Access Compliance Report

Public Rights-of-Way

Intersection ID: 29180	Main Street: BOXELDER_LN	Cross Street: BIG_LEAF_DR	Location: SE
ADA ID: 2CCAC85FDE4F	Ramp Type: BlendTrans1	Initial Pass/Fail: Pass	Overall Compliance: No
		Severity Score: 15

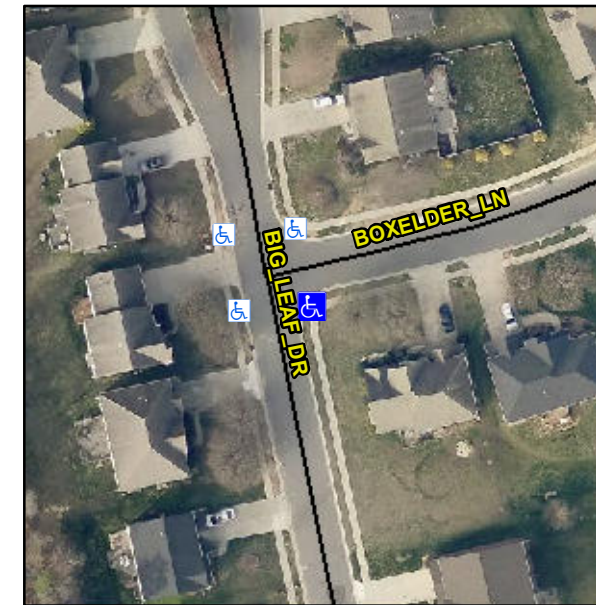
Not Found, R304.2.1, R304.2.2-Perp, R304.3.2-Para, R305, R304.5.4

N/A	Ramp inside XWalk1?	N/A	N/A	Ramp inside XWalk2?	N/A
	Road Slope (%)	0.5		Clear Space?	Yes
	Road X Slope (%)	6.2	N/A	Clear Space to XWalk (in)	N/A
Yes	Any Obstructions?	No	Yes	Storm Grate/Utility Hazard?	No
	Obstruction Type			Storm Grate/Utility Type	
		N/A			N/A
			Yes	Surface Condition? (G/P)	Good
			No	Curb Slope (%)	11.8

Remove & Replace Curb Ramp With Two New Directional Ramps or Equivalent. Remove & Replace Gutter.
